Economic Commission for Europe**Inland Transport Committee****World Forum for Harmonization of Vehicle Regulations****Working Party on Passive Safety****Sixty-sixth session**

UN Regulation No. 22 (Protective helmets)**Proposal for the 06 series of amendments of UN Regulation No. 22 (Protective helmets)****Submitted by the experts from the Informal Working Group on UN Regulation No. 22***

The text reproduced below was prepared by the experts from the Informal Working Group on UN Regulation No. 22. It is based on ECE/TRANS/WP.29/GRSP/2019/11 distributed at the sixty-fifth session of the Working Party on Passive Safety (GRSP). The modifications to the current text of UN Regulation No. 22 are marked in bold for new characters and strikethrough for deleted characters.

Figure 2D

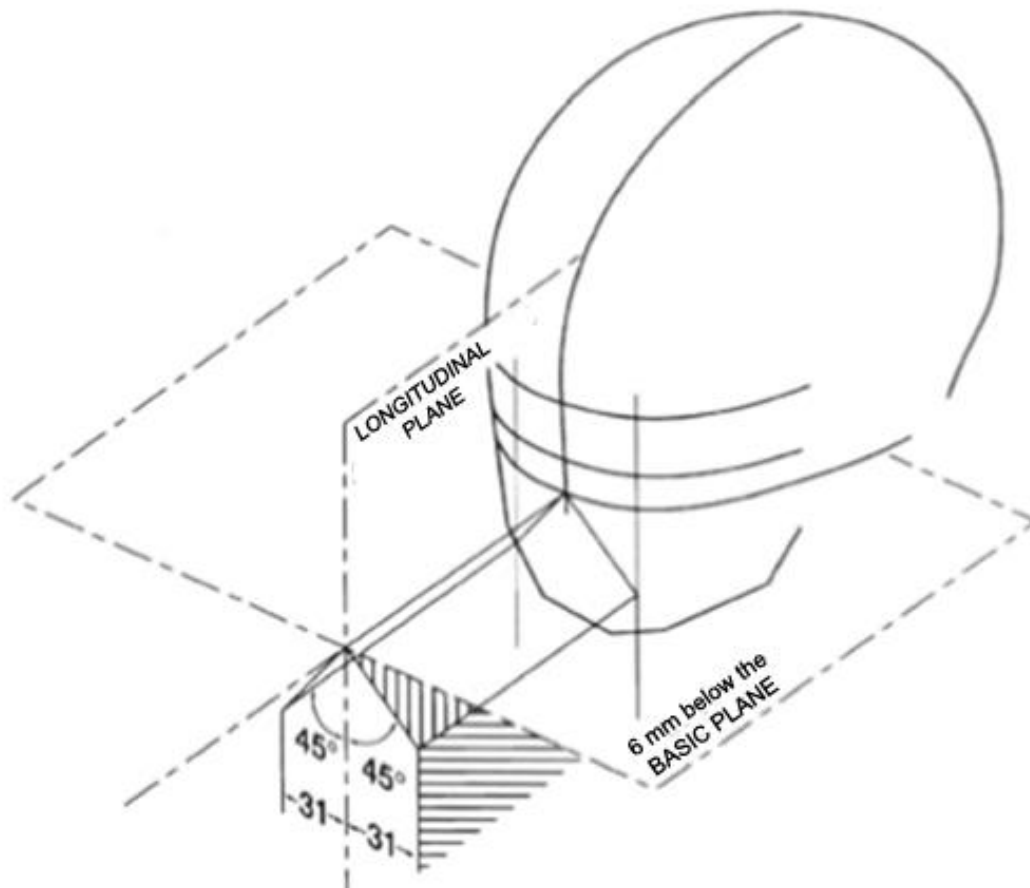
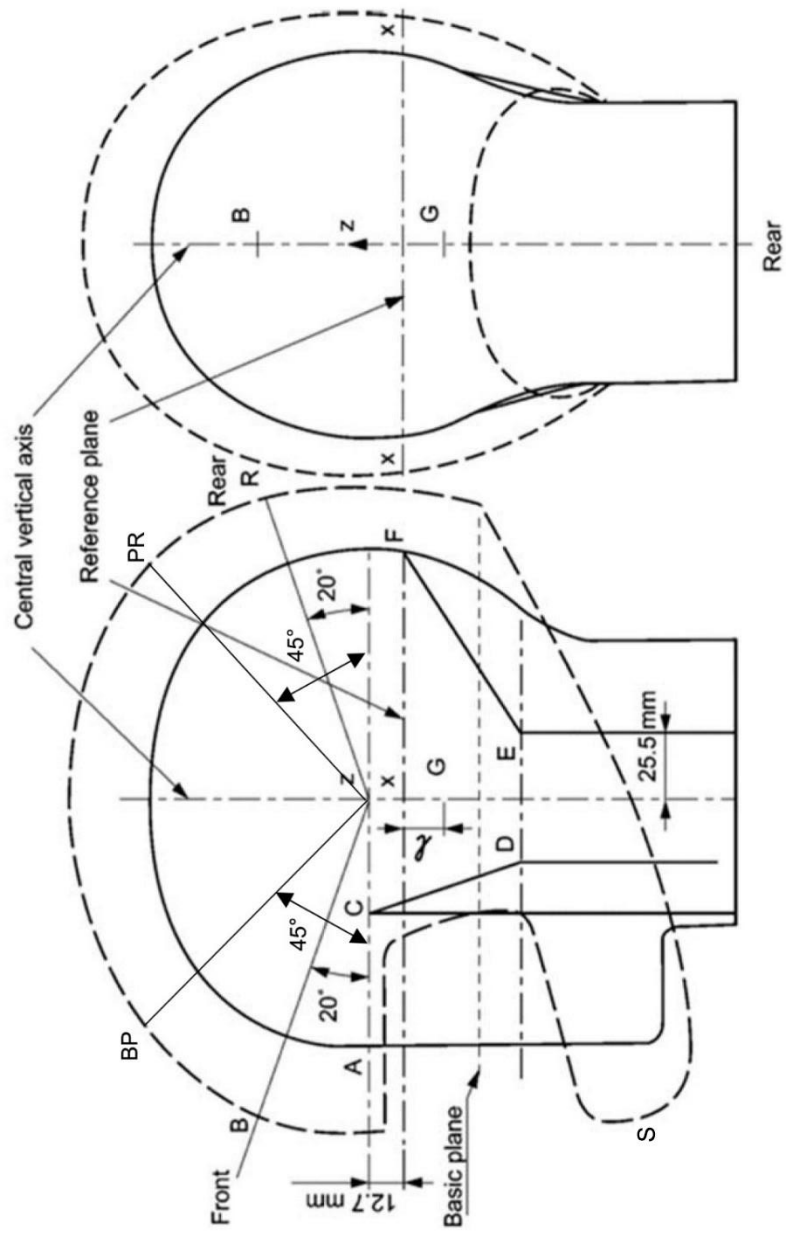
- However, this downward clearance makes specific allowance for breath deflectors.**
- The breath deflector allowance is shown in Annex 4 fig. 2D. It includes the region that is within 31 mm to the right and left of the longitudinal plane and that lies below the two planes that form 45° angles with the longitudinal plane and that intersect it at the level of the 6 mm below the basic plane.**
